Re: Oyster Creek Nuclear Station Unit 1
Forked River Nuclear Station Unit 1
Circulating Water System
Environmental Considerations

ADDENDUM

PROBABLE MAXIMUM HURRICANE FLOOD ANALYSIS
OYSTER CREEK NUCLEAR UNIT NO.1

I have reviewed the report transmitted with your letter March 2, 1972, addressed to GPU Service Corporation re "Probable Maximum Flood Analysis, Oyster Creek Nuclear Unit No. 1". My comments follow:

Attachment - Site Map

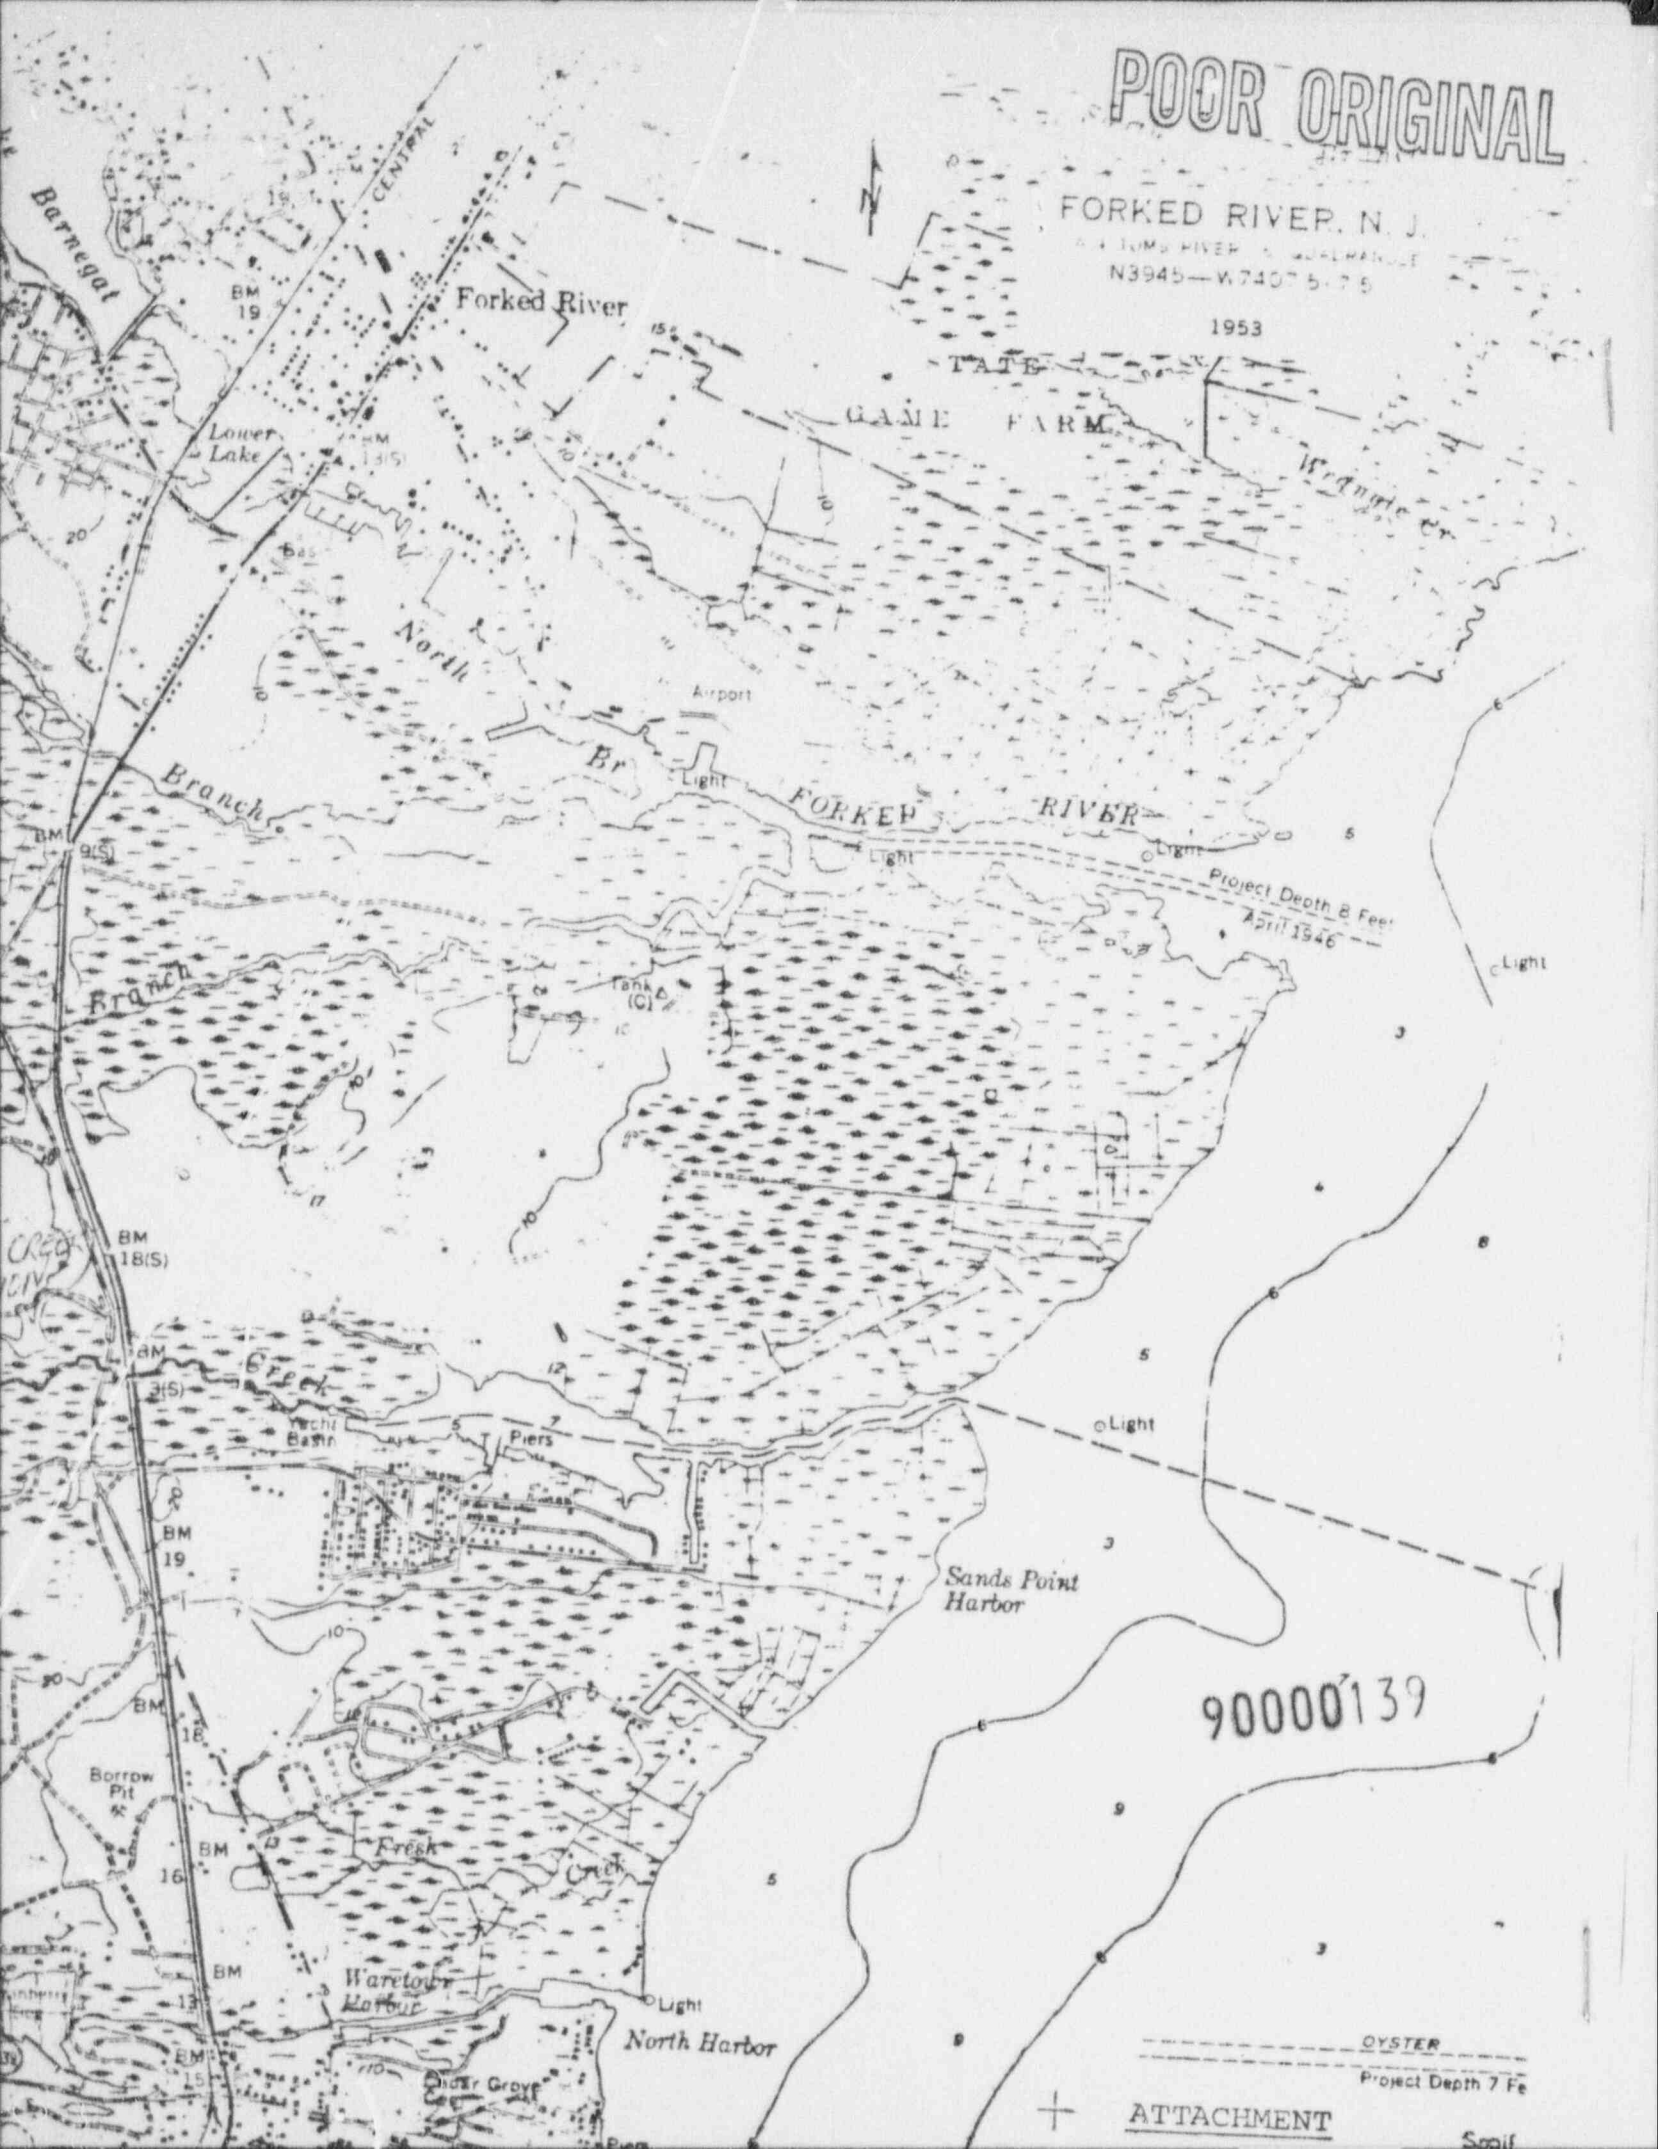
The relocated plant site is to be situated on a plateau within a 30 ft. MSL ground contour, as can be seen on the Attachment. The site is some $2\frac{1}{2}$ to 3 statute miles inland from the west shore of Barnegat Bay. It is flanked north and south by the South Branch Forked River and Oyster Creek, respectively.
